Docket Nos. 50-280 ✓
and 50-281

Licenses Nos. DPR-32
and DPR-37

Change No. 13

4.15 AUGMENTED INSERVICE INSPECTION PROGRAM FOR HIGH ENERGY LINES
OUTSIDE OF CONTAINMENT

MAIN STEAM AND FEEDWATER
 LINES - UNIT 2
 SURRY POWER STATION
 UNITS 1 AND 2

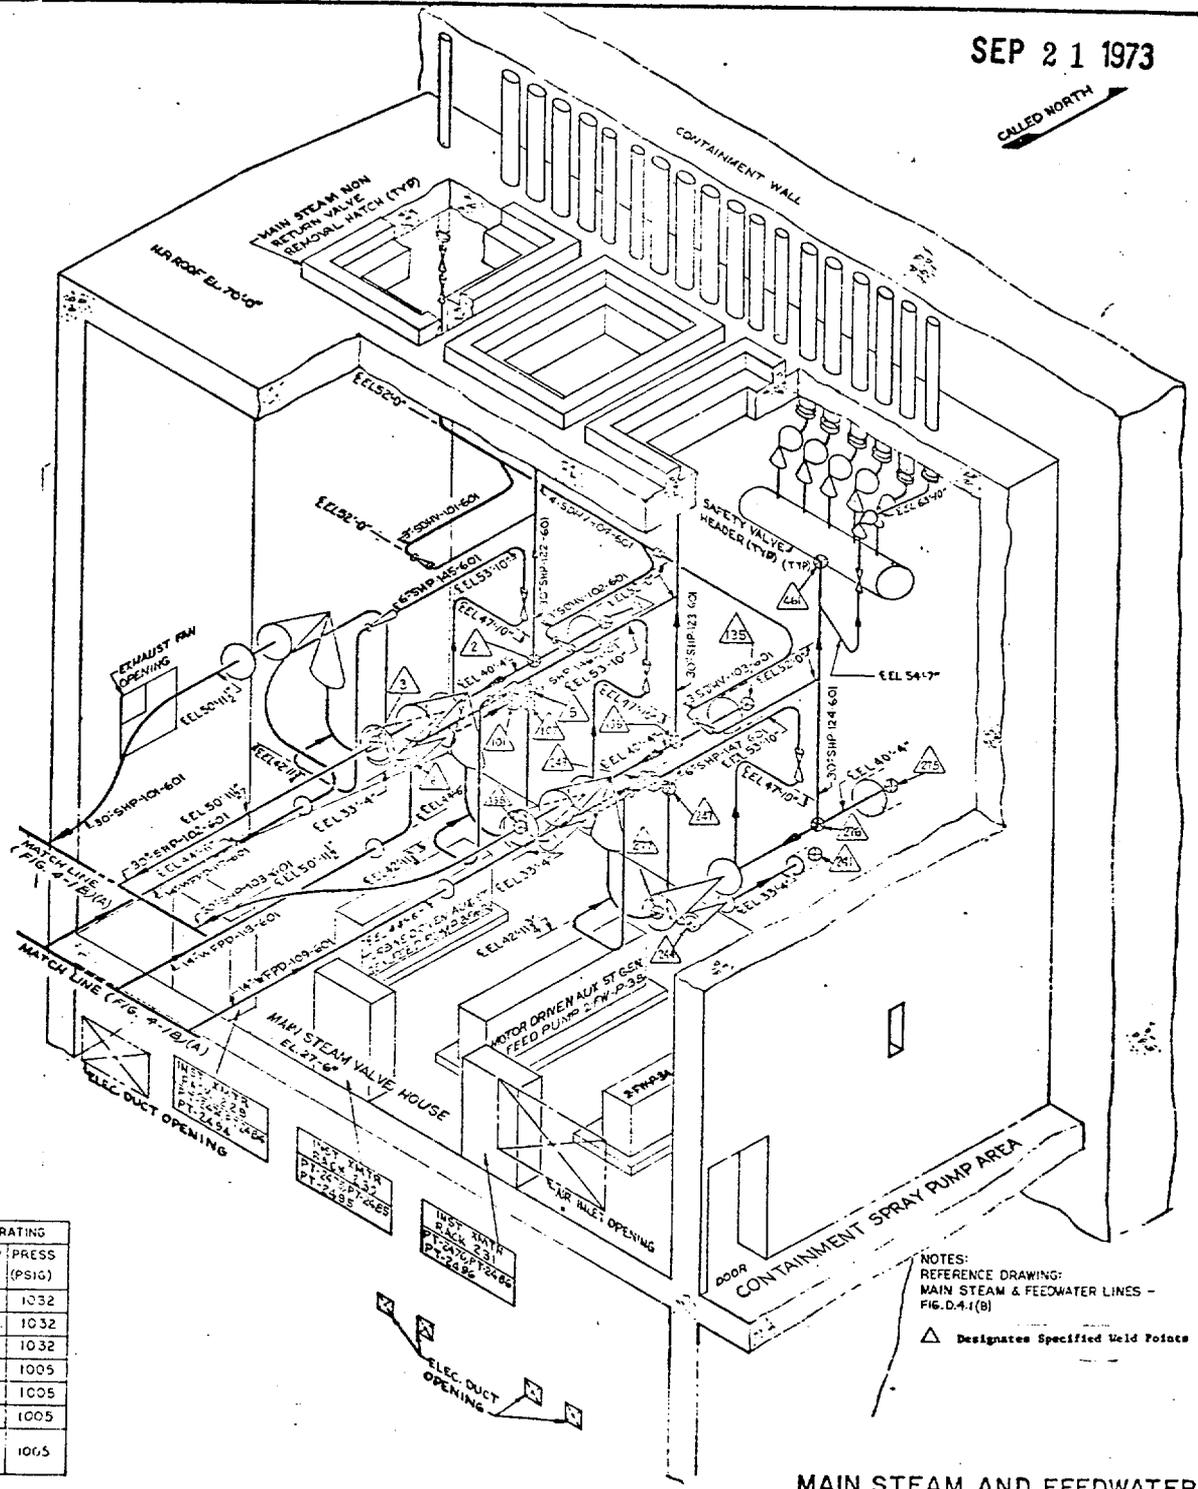
- A. For the 20 welds identified in TS Figure 4.15:
 - 1. At the first refueling outage period a volumetric examination shall be performed with 100 percent inspection of welds in accordance with the requirement of ASME Section XI Code, 'Inservice Inspection of Nuclear Power Plant Components, to

2. The inservice inspection at each weld shall be performed in accordance with the requirements of ASME Section XI Code, Inservice Inspection of Nuclear Power Plant Components, with the following schedule: (The inspection intervals identified below sequentially follow the baseline examination of TS 4.15.A.1 above):

3. Examinations that reveal unacceptable structural defects in a weld during an inspection under TS 4.15.A.2 shall be extended to require an additional inspection of another 1/3 of the welds. If further unacceptable defects are detected in the second sampling, the remainder of the welds shall be inspected.

4. In the event repairs of any welds are required following any examination during successive inspection intervals, the inspection schedule for the repaired welds will revert back to the first 10 year inspection program.
